Passive filter units for electromagnetic interference suppression –

Part 1: Generic specification

CORRIGENDUM 1

NOTE This corrigendum constitutes a revision of the structure of subclause 4.5, as well as an addition to subclause 4.10.3.

Figure 2 – Examples of the application of Table 3

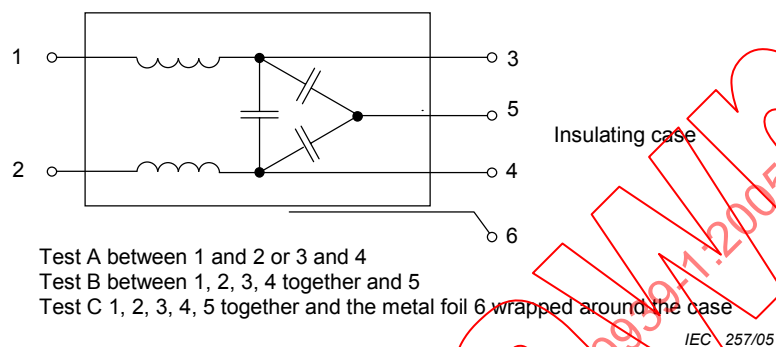
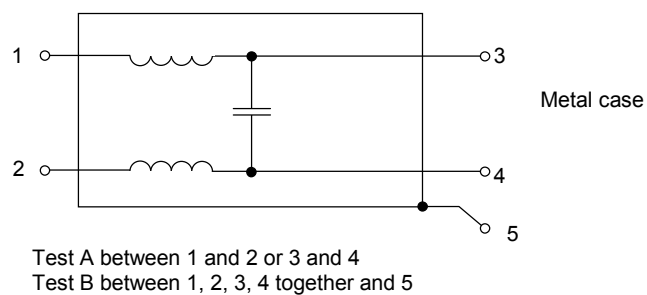
Replace the text from 4.5 to the end of 4.5.3.5 by the following:

Tests	Description
A Between terminations	Between pairs of lines carrying the load current through the suppression components e.g. line-line or line-neutral.
B Internal insulation	Between the load current terminations connected together and the case (except where the case is one termination) (metal cased types only) or between the load current termination and the earth termination.
C External insulation	Between the load current terminations connected together and the metal plate or foil or V-block (insulated cases not employing metal) or between case and metal plate or foil or V-block (insulated metal cased types only).
NOTE See Figure 2 for examples of the application of this table.

Figure 3 – Test circuit for d.c. test

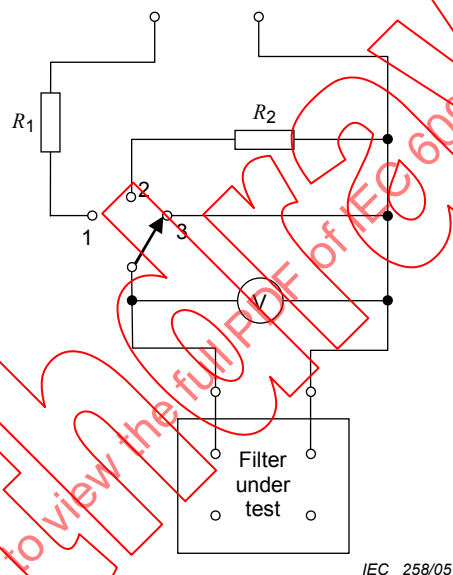
Replace 4.5.4 and its subclauses by the following new 4.6

For Test A, where the test voltage will normally be applied across a capacitor, the test circuit shall be such that the conditions relating to the charging and discharging currents and the time constant for charging, prescribed in the relevant specification, are complied with.

The resistance of the voltmeter shall be not less than 10 000 Ω/V .

The resistor R_1 includes the internal resistance of the d.c. supply.

The resistors R_1 and R_2 shall have a resistance of sufficient value to limit the charging and discharging current to the value prescribed in the relevant specification.
